# SERVICE BULLETIN

ENGINE - HP COMPRESSOR - REPLACE A BRACKET AT FLANGE FJ - CATEGORY CODE 5 -  
MOD.ENG-72-0080

- (1) Aircraft: Airbus A320
- (2) Engine: V2500-A1 Engine, prior to Serial Number V0122

Location of Clipping Point CP5696  
Fig.1

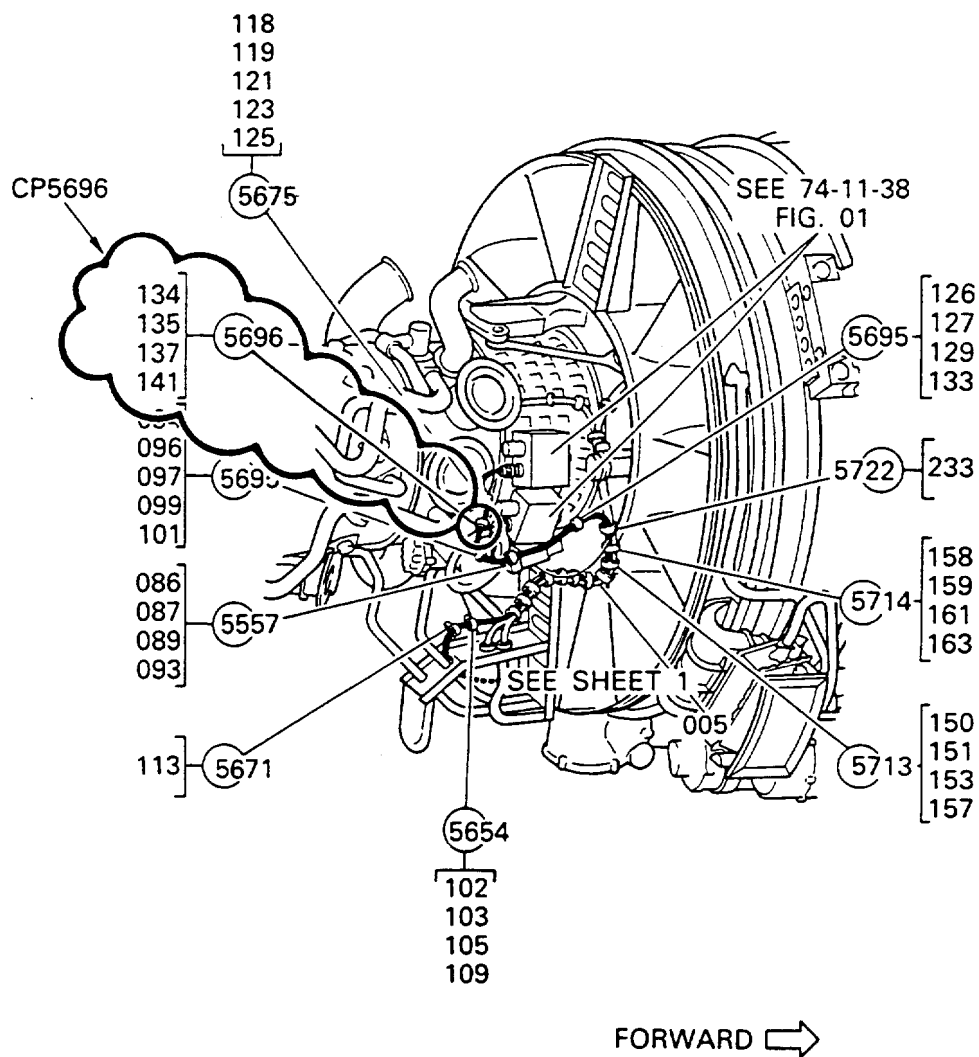
There may be insufficient clearances between the EEC Core Harness Clamp at CP5696 and the 7th Stage Bleed Valve Duct, and also between the clipping Bracket at CP5696/CP5643 and the Stage 7 HPC Bleed Valve Air Tube because of inadequate Bracket location at Flange FJ.

(a) The existing Bracket 5W1997, which supports the Harness and the Stage 10 HPC Bleed Valve Air Tube is replaced with the new Bracket 5W8396, and the installation location at Flange FJ is changed from the rear side to the front side.

- (1) Assemble the new 5W8396 bracket by use of the approved procedures, Engine Manual, 72-41-00, Assembly-02.
